# Access Compliance Report

## Public Rights-of-Way

Intersection ID: 30436	Main Street: MARIANNES RIDGE RD	Cross Street: STEELE MEADOW RD	Location: SW
ADA ID: E1B8259817C1	Ramp Type: PerpDiag	Initial Pass/Fail: Fail	Overall Compliance: No
Severity Score: 12.5			
Codes/Mitigation Info/Possible Solution		Field Measurements/Component Compliance

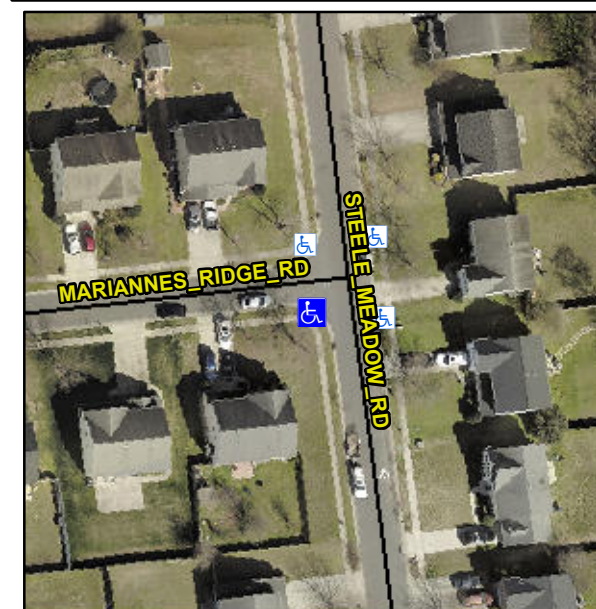
Compliance	Description	Data	Compliance	Description	Data
N/A	Ramp Length (in)	48.0	No	Ramp Slope (%)	8.7
Yes	Ramp Width (in)	48.0	Yes	Ramp XSlope (%)	0.5
N/A	Flare Type LT	N/A	N/A	Flare Type RT	N/A
N/A	Flare Slope LT (%)	N/A	N/A	Flare Slope RT (%)	N/A
N/A	Flare Traversable LT?	N/A	N/A	Flare Traversable RT?	N/A
N/A	Landing Length (in)	N/A	N/A	DWS Provided?	N/A
N/A	Landing Width (in)	N/A	N/A	DWS Contrast?	N/A
N/A	Landing Slope (%)	N/A	N/A	DWS Length (in)	N/A
N/A	Landing X Slope (%)	N/A	N/A	DWS Full Width?	N/A
N/A	Landing Curb? (Y/N)	N/A	N/A	DWS Offset (in)	N/A
N/A	Shared Landing?	N/A			
N/A	Gutter Ponding?	N/A	N/A	Gutter Slope (%)	N/A
N/A	Gutter Lip Ht (in)	N/A	N/A	Gutter X Slope (%)	N/A
N/A	Painted X Walk1?	No	N/A	Painted X Walk2?	No
	X Walk 1 Direction	To E		X Walk 2 Direction	To N
N/A	X Walk 1 Width (in)	N/A	N/A	X Walk 2 Width (in)	N/A
	X Walk 1 Slope (%)	2.3		X Walk 2 Slope (%)	2.0
	X Walk 1 X Slope (%)	0.5		X Walk 2 X Slope (%)	1.1

**Remove & Replace Curb Ramp With Two New Directional Ramps or Equivalent.**
